SERVICE BULLETIN

SERVICE BULLETIN		NO.: ESB-96E37-002	
		DATE: 1996-07-30	<MODEL> CARISMA <M/Y> 96-10
SUBJECT: CHANGE OF POWER STEERING RETURN HOSE AND BOLT TIGHTENING TORQUES			
GROUP: STEERING			
INFORMATION:		 O. Kai -E.V.P. After Sales Service

POWER STEERING HOSES

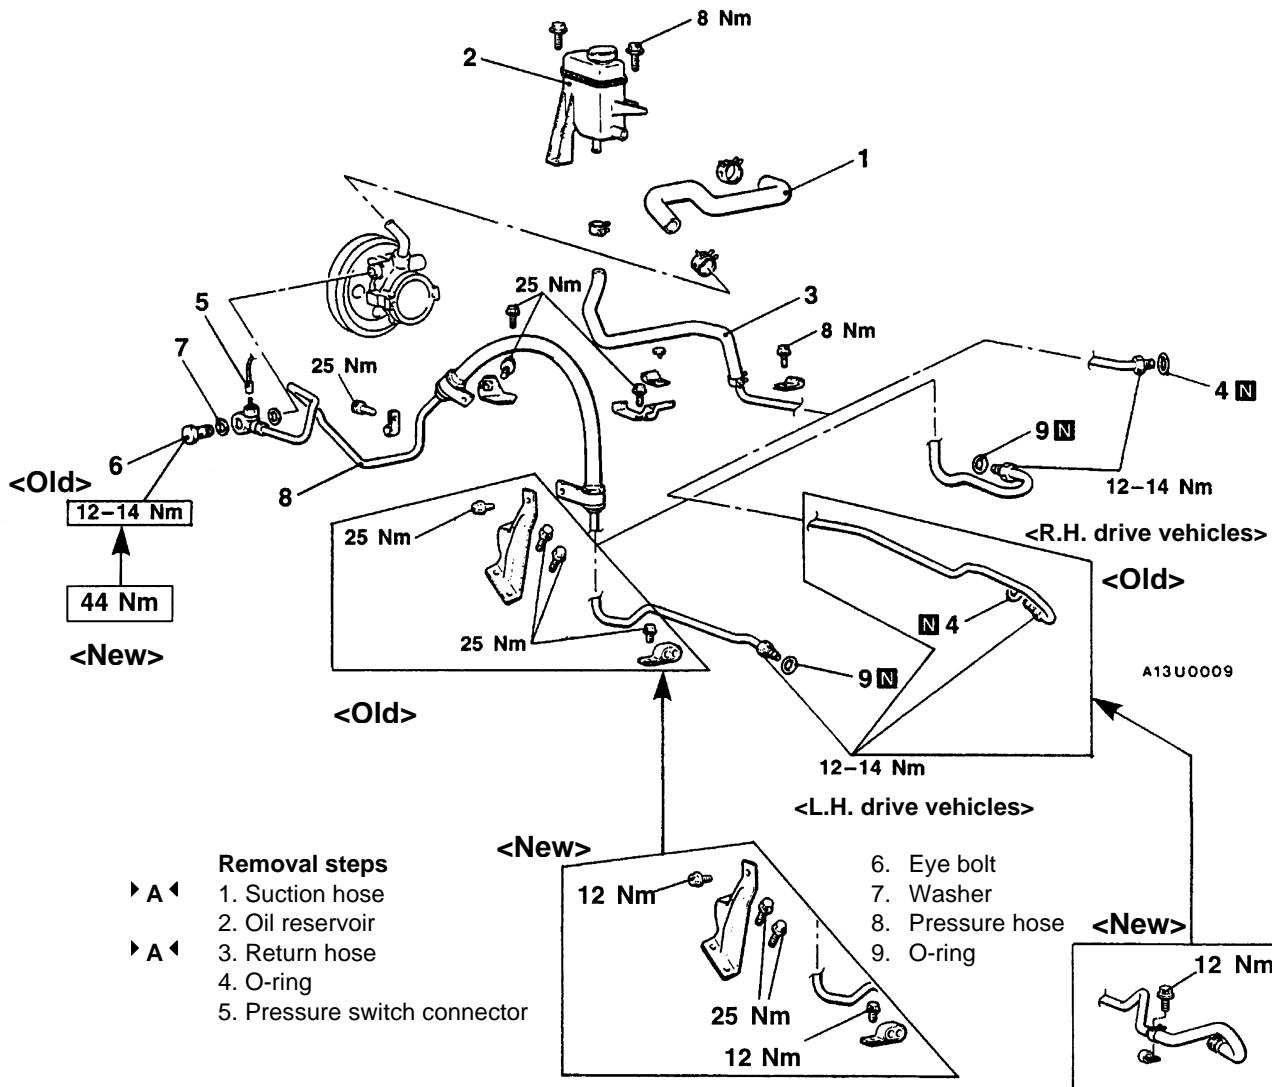
The power steering return hose has been changed on left-hand drive models. In Addition, the tightening torque specifications for pressure hose attaching bolts and Eye bolts have been changed.

Return hose: From September 21, 1995

Pressure hose attaching bolt and eye bolt torques: From July 12, 1995

Connect the hose so that the marking is facing upwards.
